Addendum No. C

To the contract documents for NORTH VERDEMONT ELEMENTARY SCHOOL, DSA No. 04-122168

For the SAN BERNARDINO CITY SCHOOL DISTRICT

LPA Project No.: 30899

05

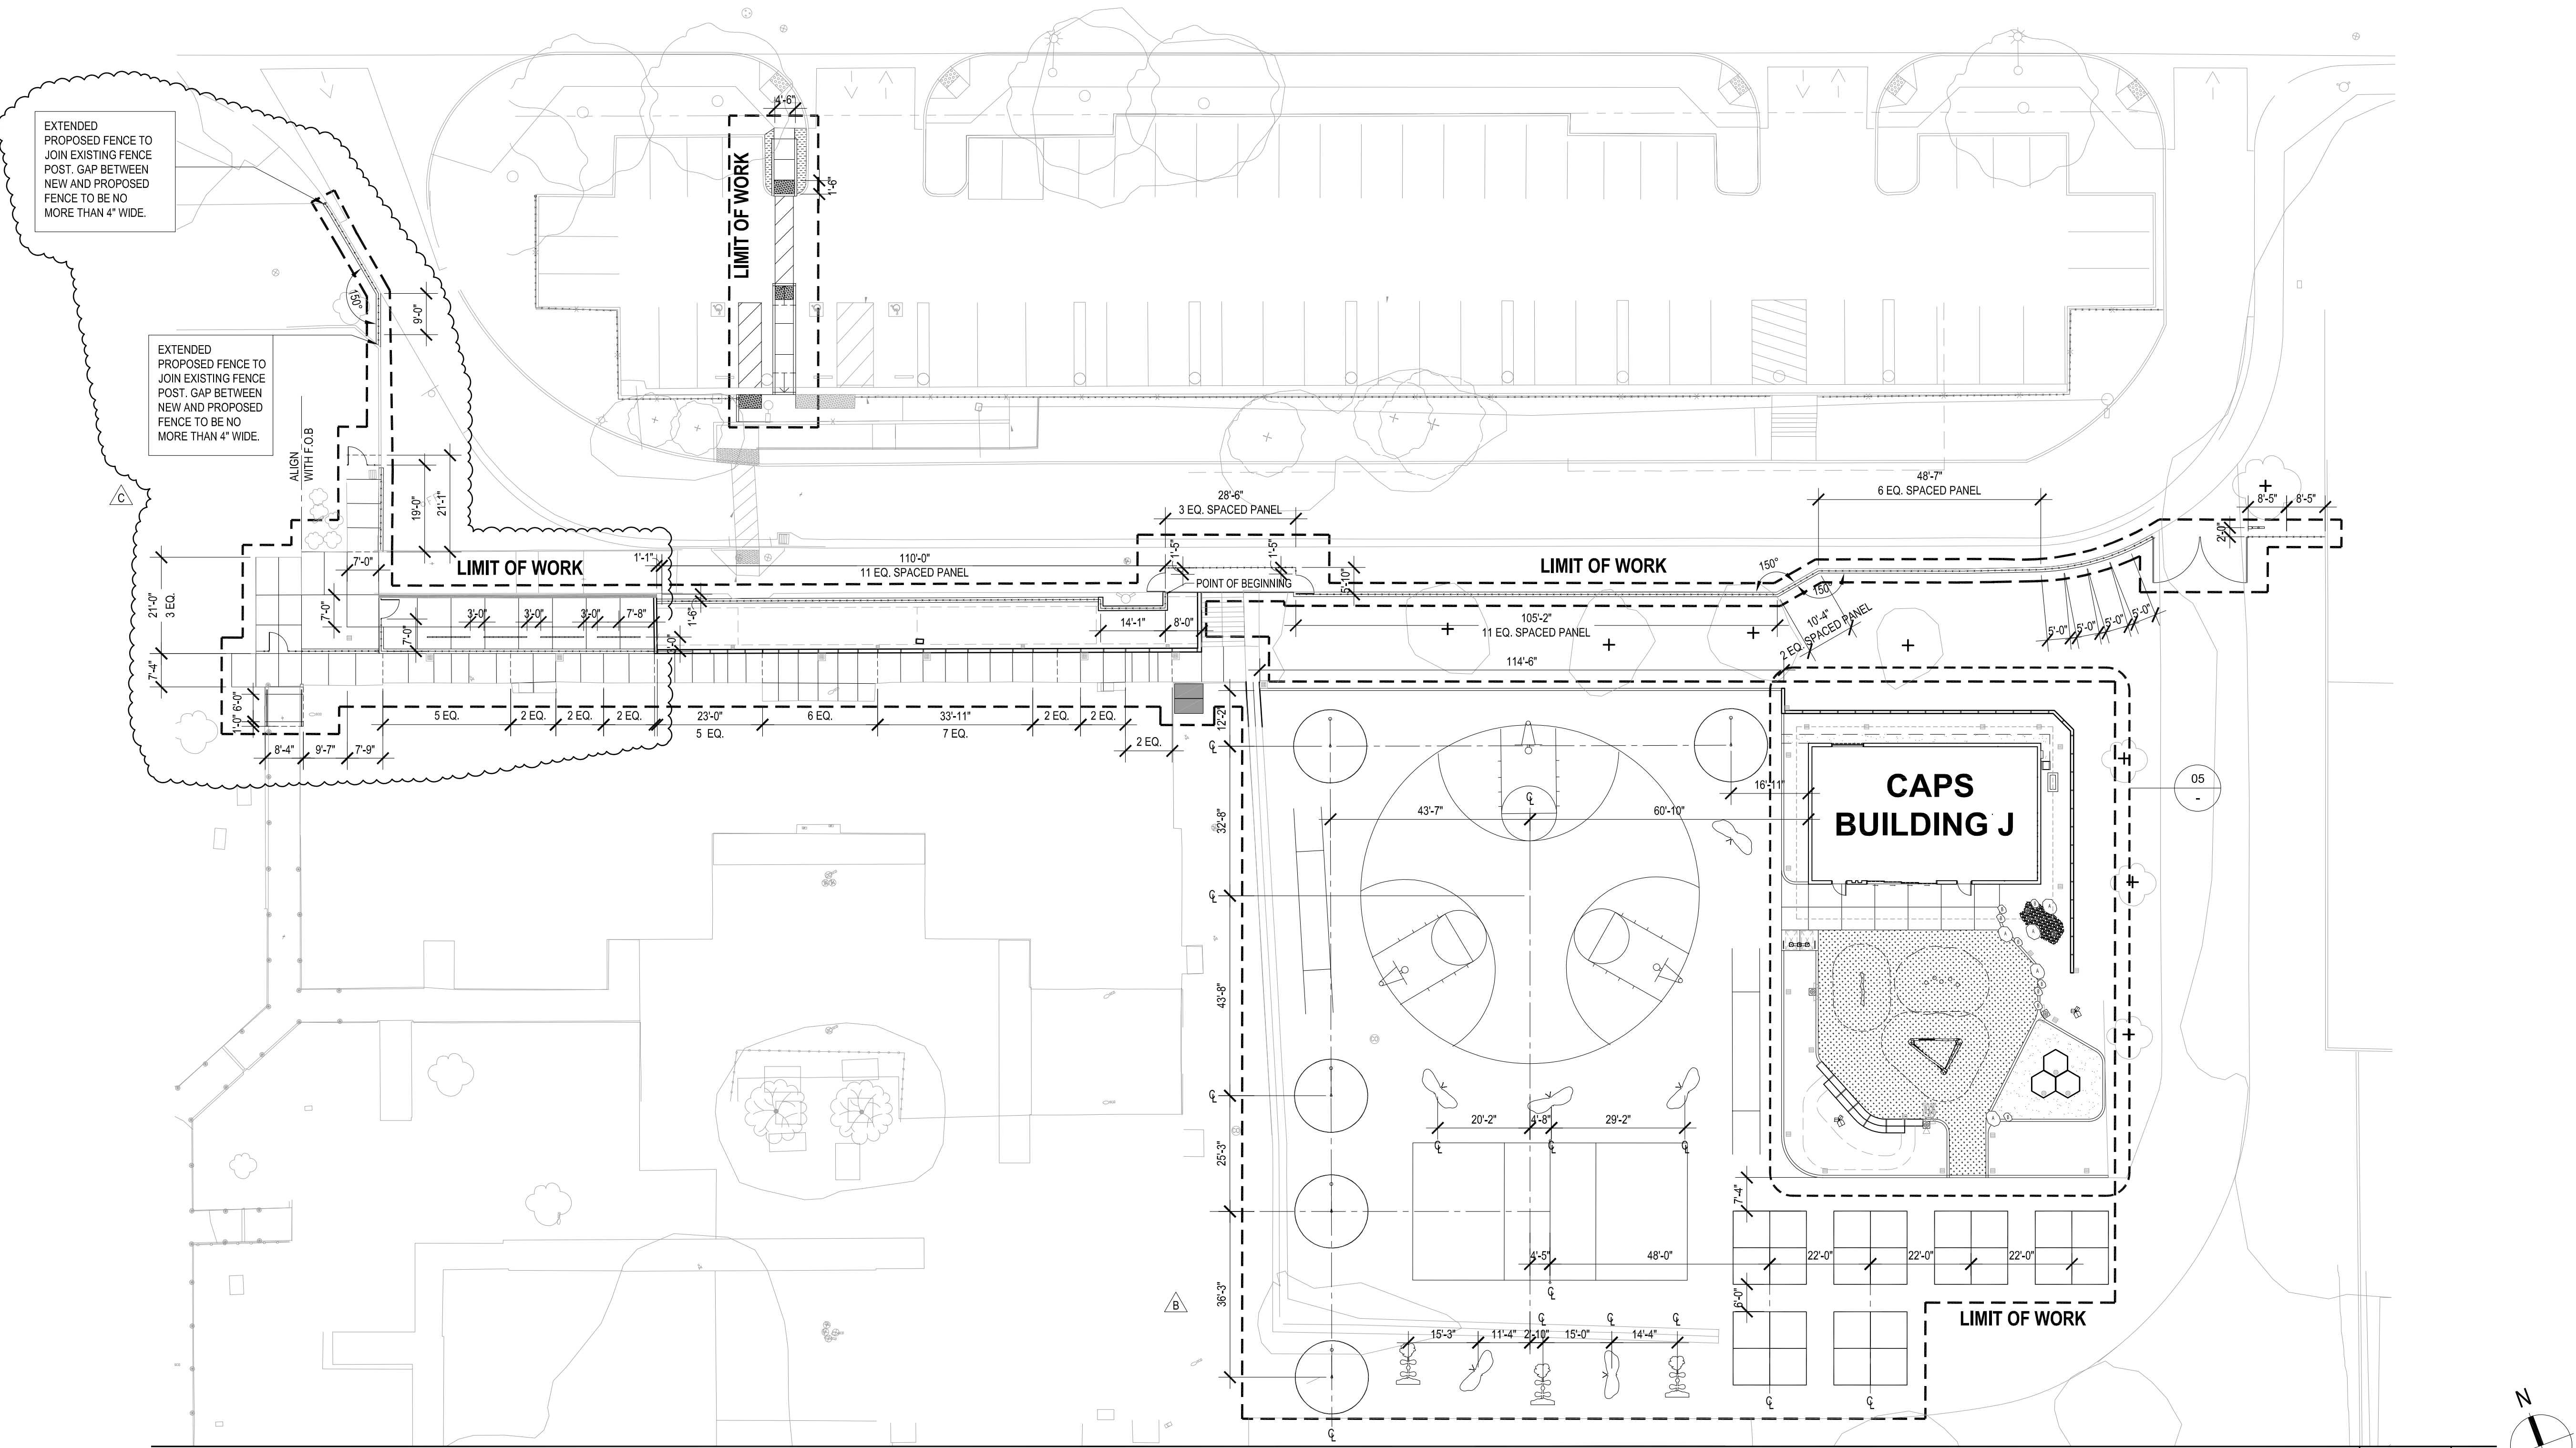
- a) Keynotes added.
- Item No. 14**      L1.01 – Materials Plan
  - a) Revised single point of entrance into campus.
  - b) Replaced existing bike racks with new.

- c) Added notes about reducing existing chainlink fence height.
- Item No. 15**      L2.01 – Layout Plan
  - a) Revised layout around single point of entrance into campus.
